**Report Type:** CC Access Report  
**Reference Number:** 21447  
**Client:** Cook Parade Childcare centre  
**Site Address:** 41 Cook Parade, St Clair NSW 2760

# ACCESS REPORT

This Access Compliance Report is to accompany a Construction Certificate Application for the development proposed at 41 Cook Parade, St Clair NSW 2760

Issue	Date	Details
Draft 1	08-12-2021	Issued for Architect's review
Issue A	15-12-2021	Issued for CC

[Image description: Plan of Ground level above shows the provision of Accessible parking space]

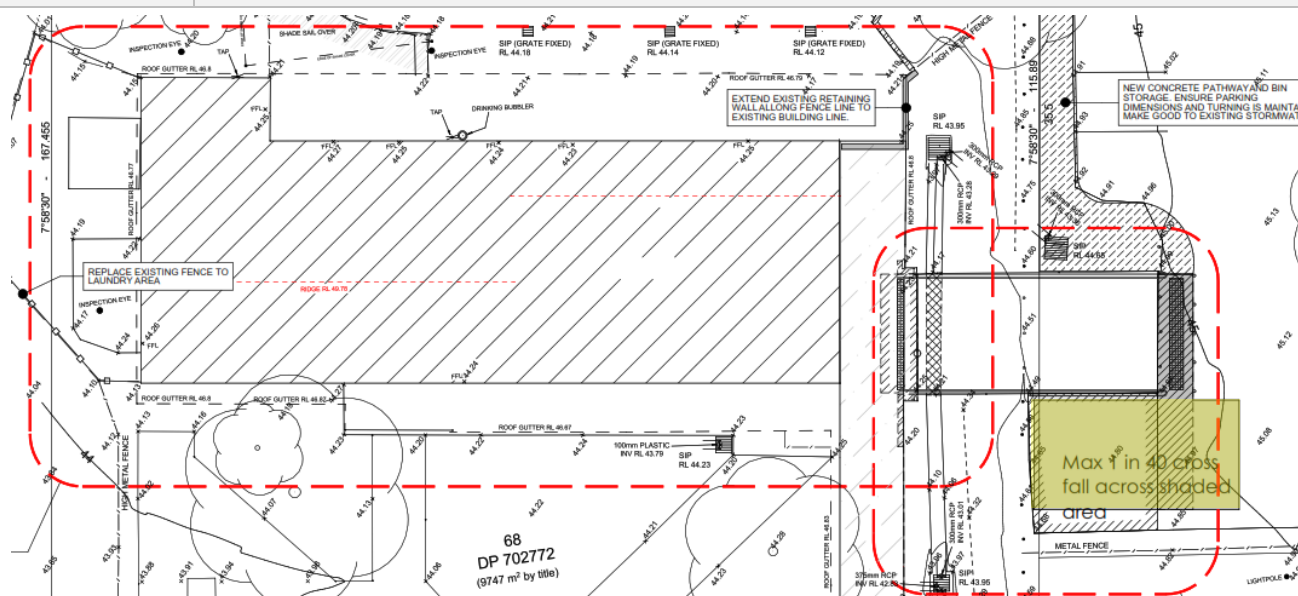
<b>Compliance Comments</b>	<p>Complies.</p> <p>Total number of Accessible parking spaces required / provided in the development = 1</p>
